**Re: Niblack Exploration Project – Response to Additional Information Request;  
Marine Facility ACOE Section 404 Permit Application**

**POA-1982-290-M~~/~~N**

Sheet 3 of 6

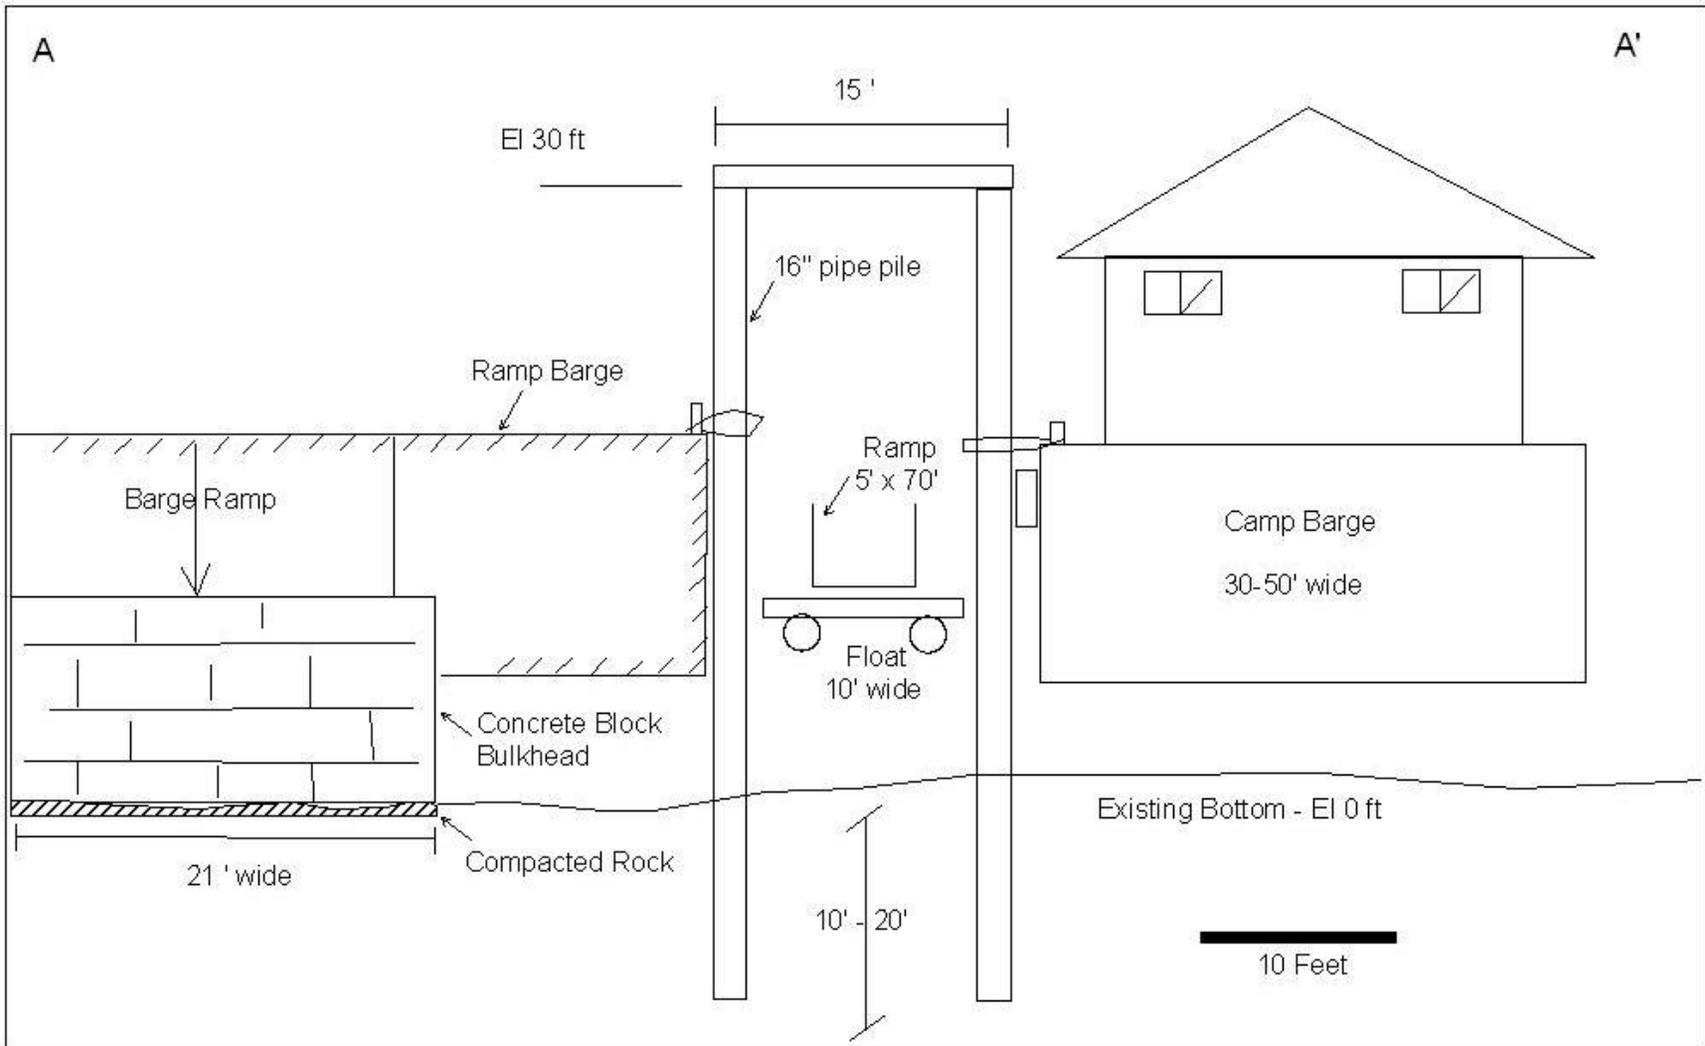
*g) The application indicates that siting will be done to avoid eelgrass beds to the extent practicable; please provide a map of the eelgrass bed locations*

Recent eel grass mapping by a biologist with HDR Alaska Inc. has identified the location of eel grass within the anchorage. No eel grass is mapped within the 1.61 acre area of the proposed marine facility outlined on Sheet 3 (attached figures). A map of eel grass distribution will be submitted to the ACOE following receipt of final report from HDR Alaska Inc.

<b>NIBLACK MINING CORPORATION</b>	
Marine Facility Diagram Section A - A'	
Location T78S R88E Meridian: Copper River	
February 5, 2007	Sheet 4 of 6

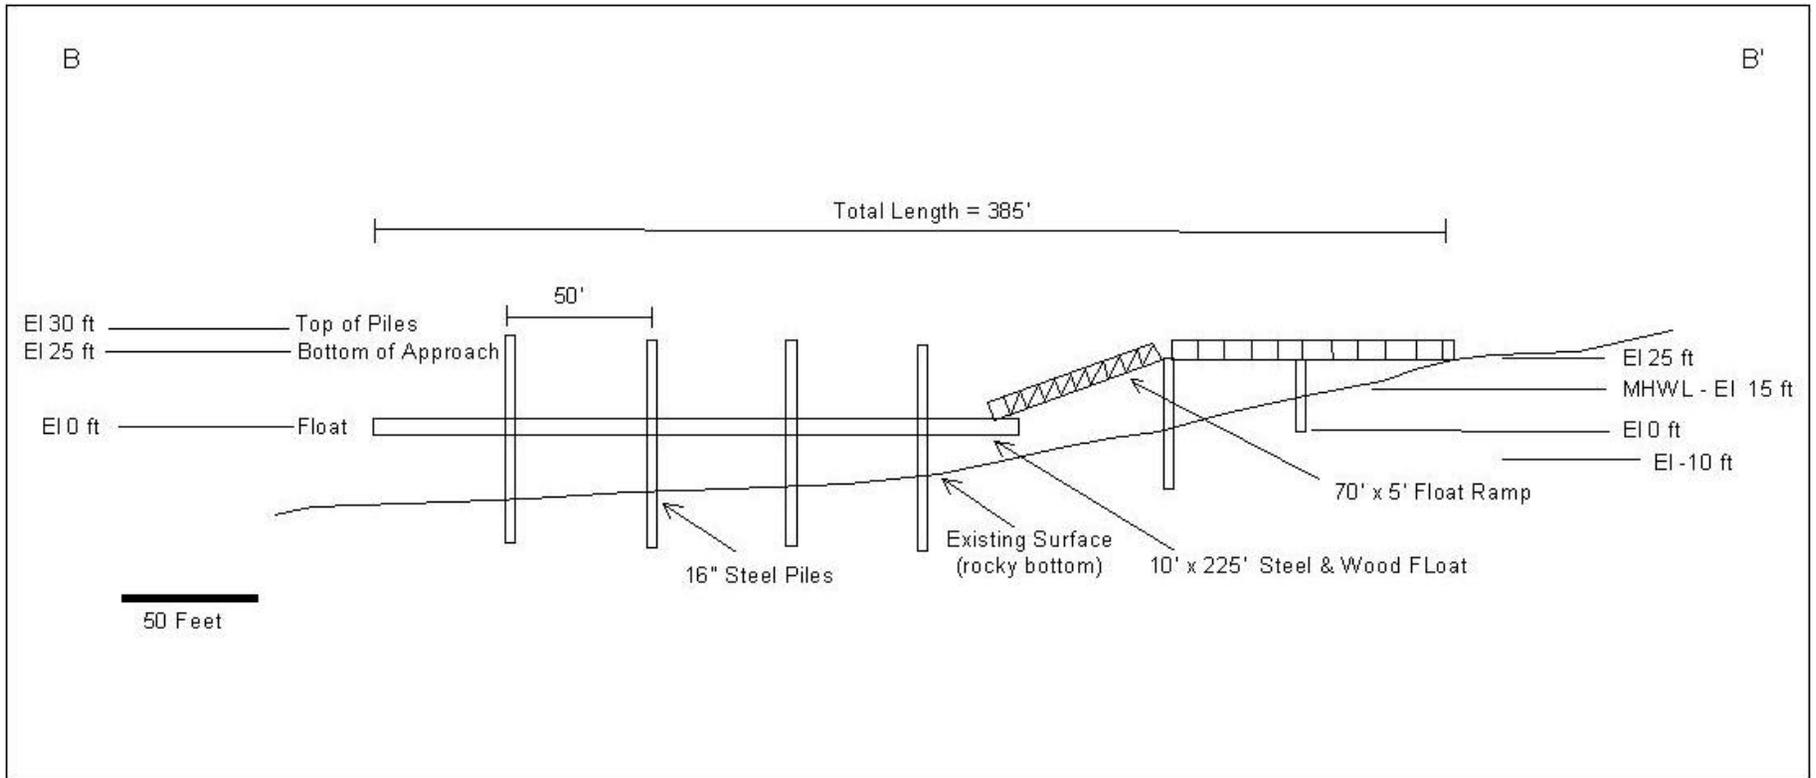
*a) Size of pilings proposed and method of installation*

Please see attached figures (Sheet 4). Pilings will be 16 inch diameter, and will be installed with a vibratory hammer and/or pneumatic double acting hammer

NIBLACK MINING CORPORATION	
Marine Facility Diagram Section B - B'	
Location T78S R88E Meridian: Copper River	
February 5, 2007	Sheet 5 of 6

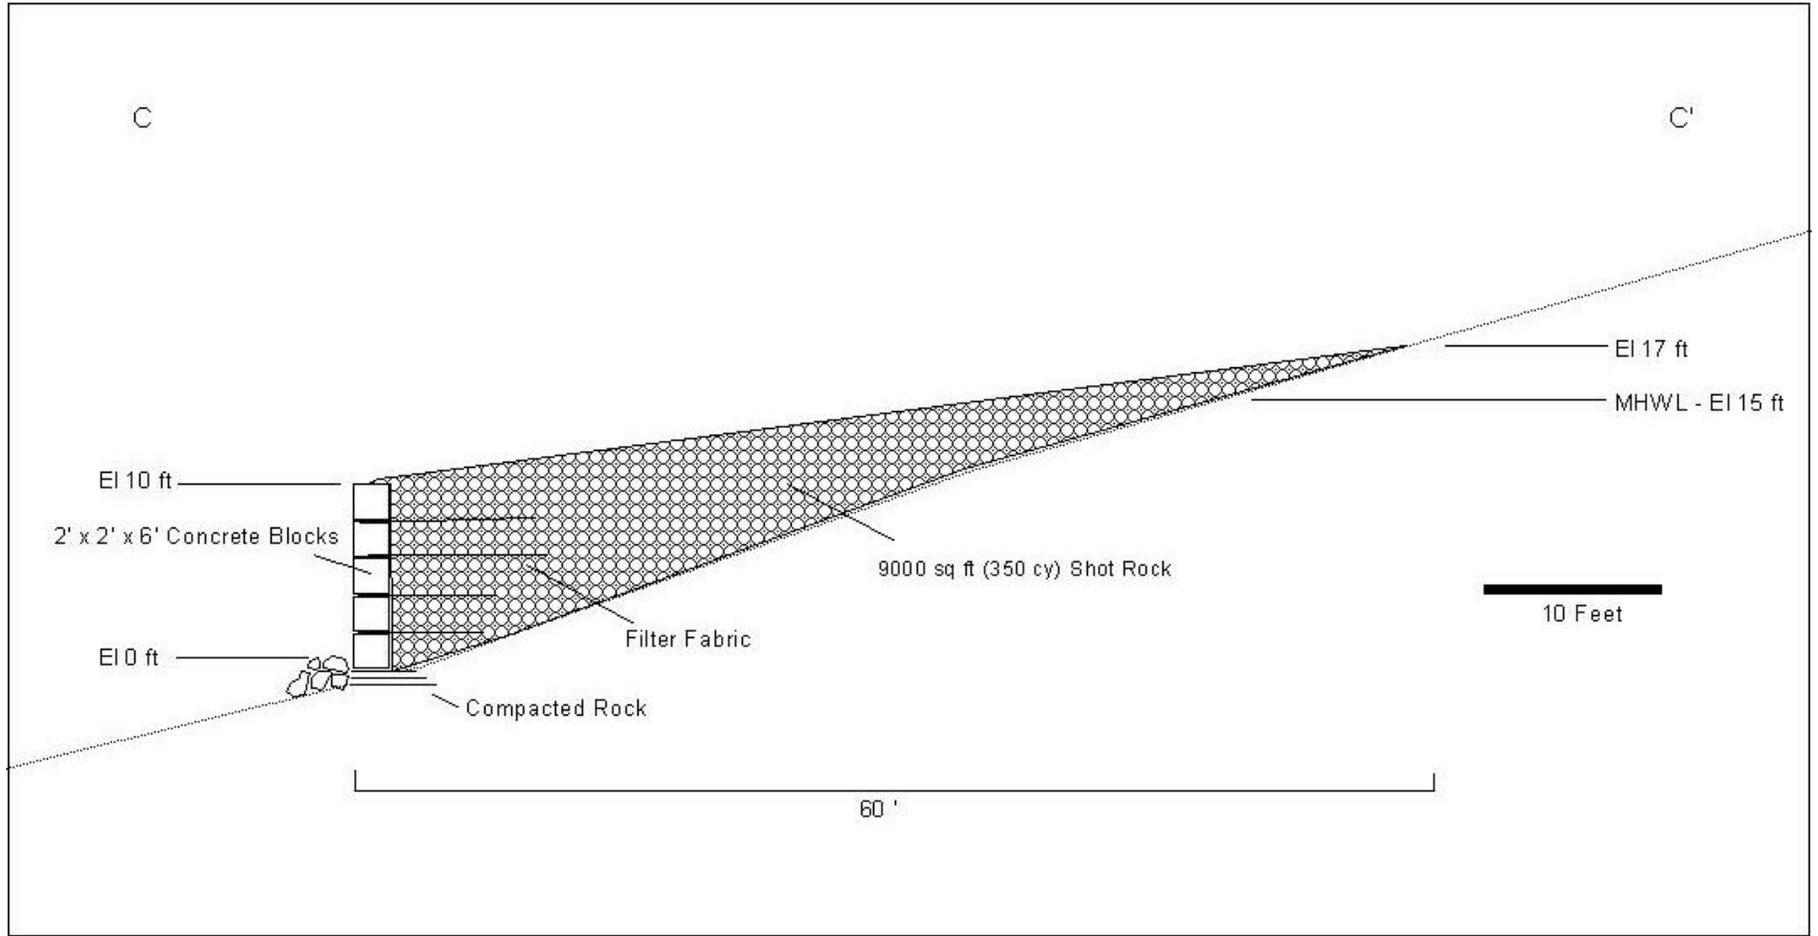
- k) *The location map on Sheet 5 does not match up with the cross-section, (i.e., A-A' does not accurately match up; and the walkway extends to the high tide line on sheet 4, but on sheet 5 it extends to the 24-foot elevation, etc.) Please depict the accurate information.*

- m) *Please re-label A-A' as B-B' on sheet 5 for clarity.*

See attached figures.

See attached figures.
